1	19.02.25	HG	Red annotations added to drawings to denote the changes made to the design as part of the NMA submission as requested by MCC.
	12.02.25		Drawing supersedes LR-BTP-00-SP-DR-A-3788_110
Rev	Date	Int	Description

PROJECT:
Lathbury Road, Manchester

DESCRIPTION:
Waste Management Plan and Detail

PURPOSE OF ISSUE: Planning			
DRAWN BY:	CHECKED	DATE:	SCALE @ A1:
HG	VS	12.02.25	As indicated
JOB NO:	STATUS CODE:	DRAWING NO:	REV
3788	S2	114	1
FILE IDENTIFIER: LR-BTP-00-SP-DR-A-3788_114.1

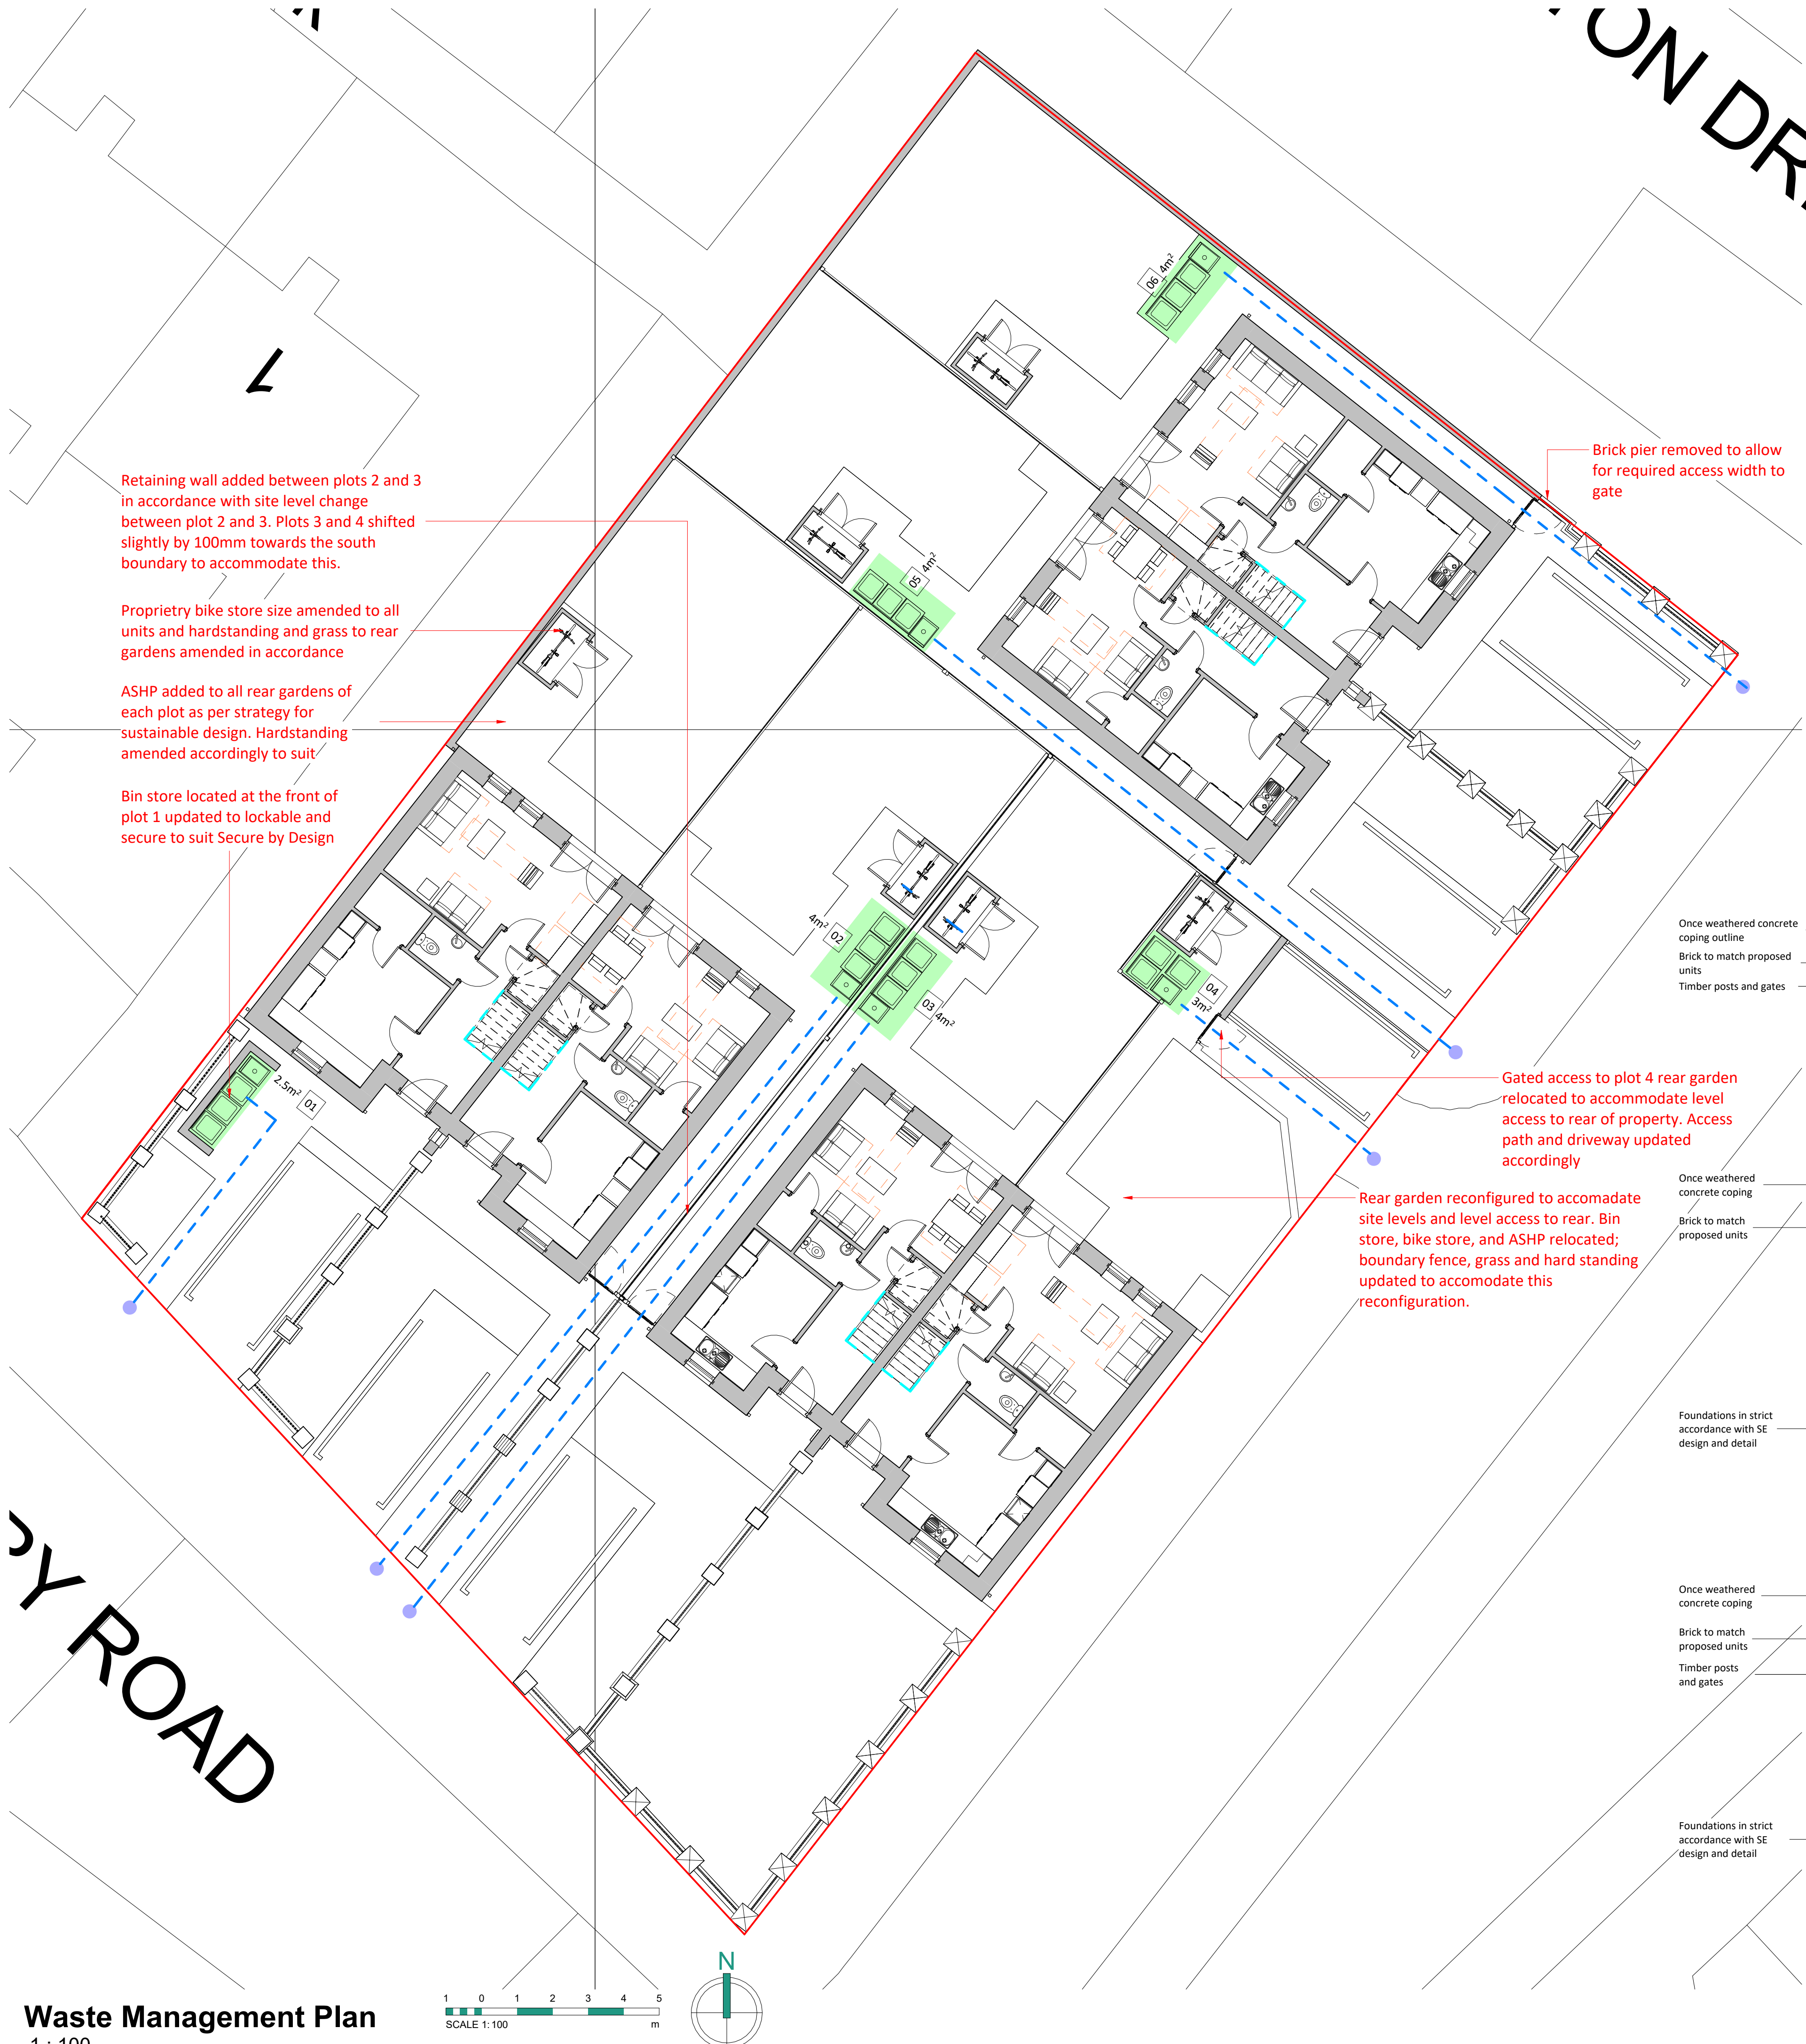
Gated access to plot 4 rear garden relocated to accommodate level access to rear of property. Access path and driveway updated accordingly

Rear garden reconfigured to accomadate site levels and level access to rear. Bin store, bike store, and ASHP relocated; boundary fence, grass and hard standing updated to accomodate this reconfiguration.
